H. B. ROBINSON STEAM ELECTRIC PLANT UNIT NO. 2

AMENDMENT TO FACILITY OPERATING LICENSE

Amendment No. 41
License No. DPR-23

ATTACHMENT TO LICENSE AMENDMENT NO. 41

Figure 6.2-1

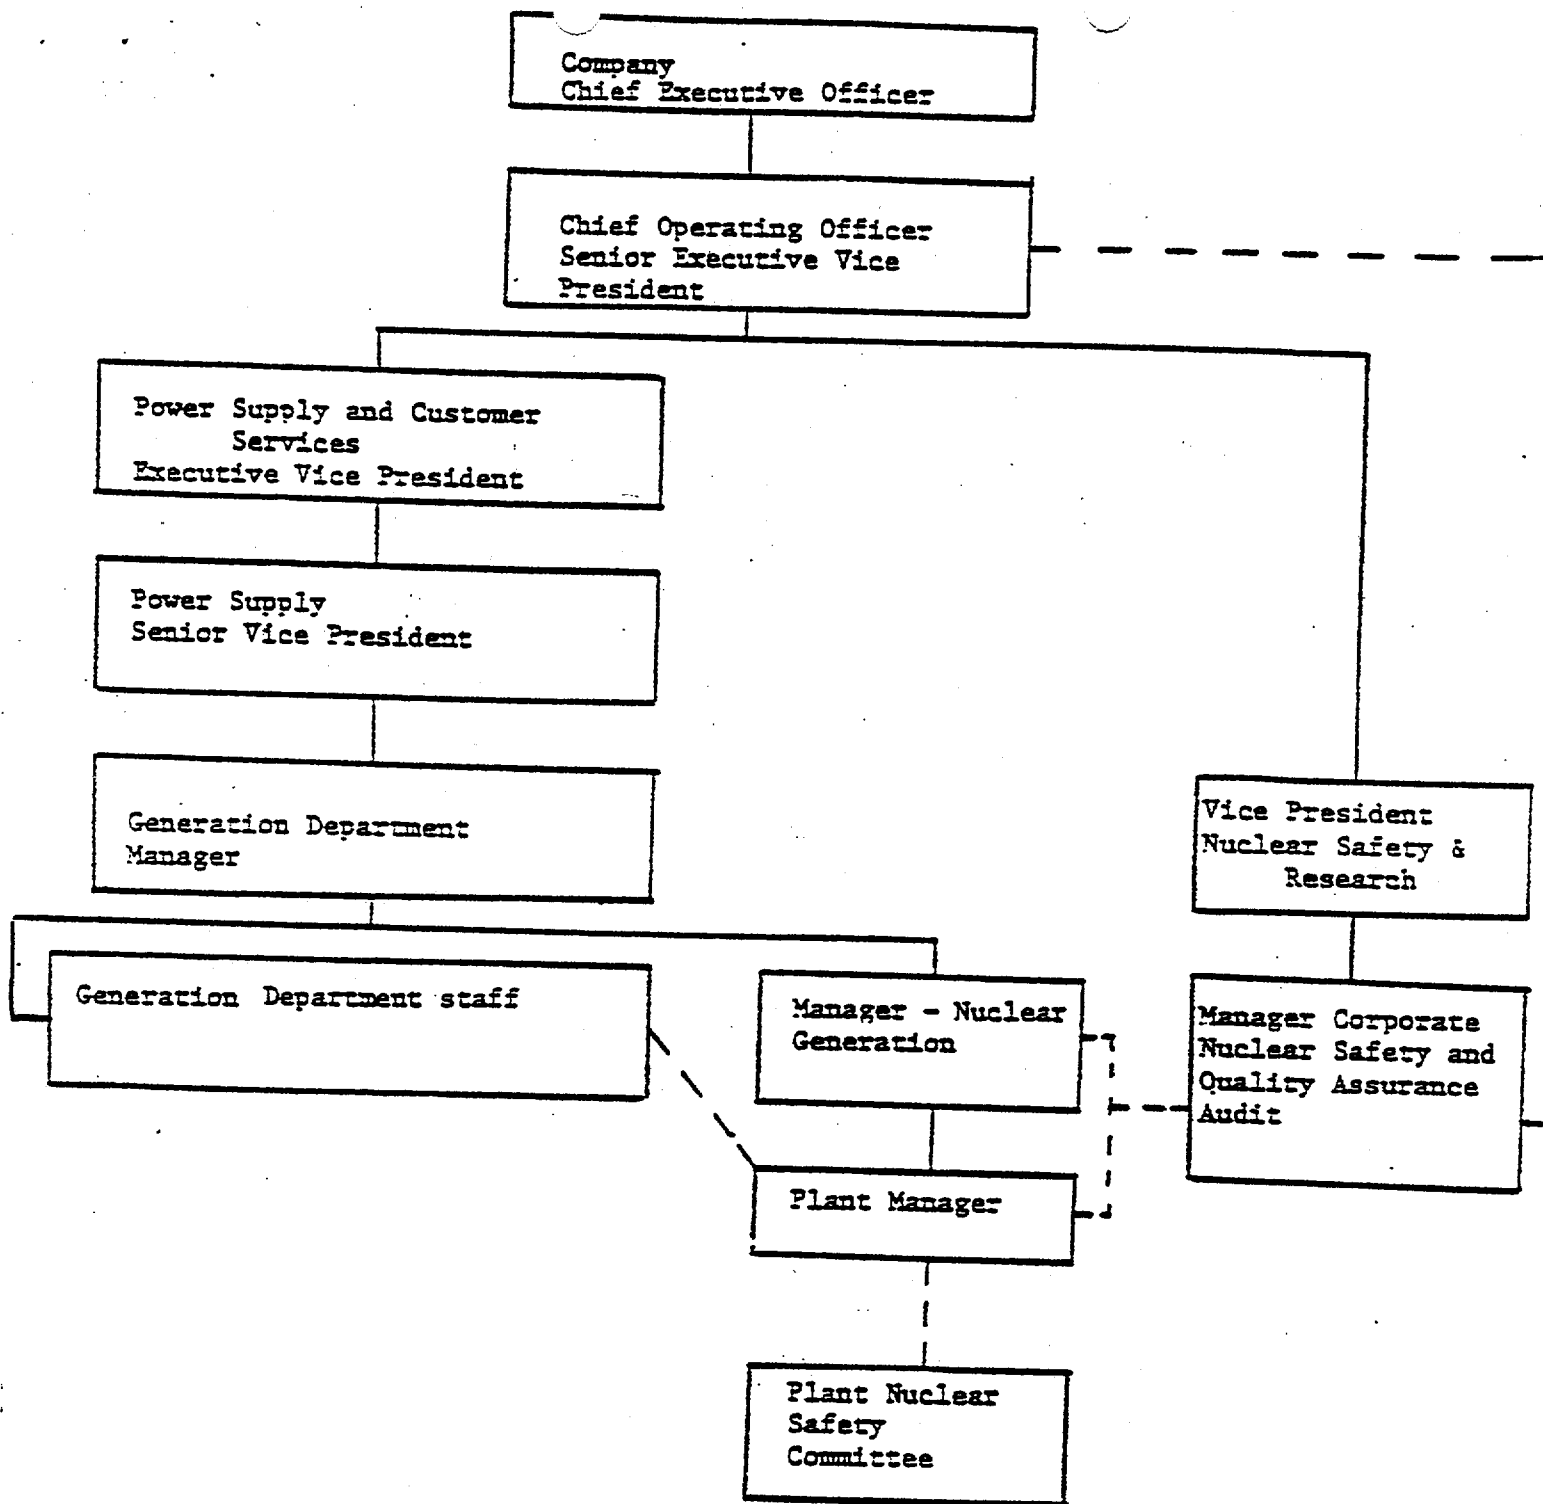
This amendment revises the Technical Specifications to reflect corporate organization changes at H. B. Robinson, Unit 2. In addition, a change has been made to the audit frequency for the Security Plan. This change brings the Technical Specifications into agreement with the approved Security Plan.

Replace the following pages of the Appendix "A" Technical Specifications with the enclosed pages. The revised pages are identified by amendment number and contain vertical lines indicating the area of change.
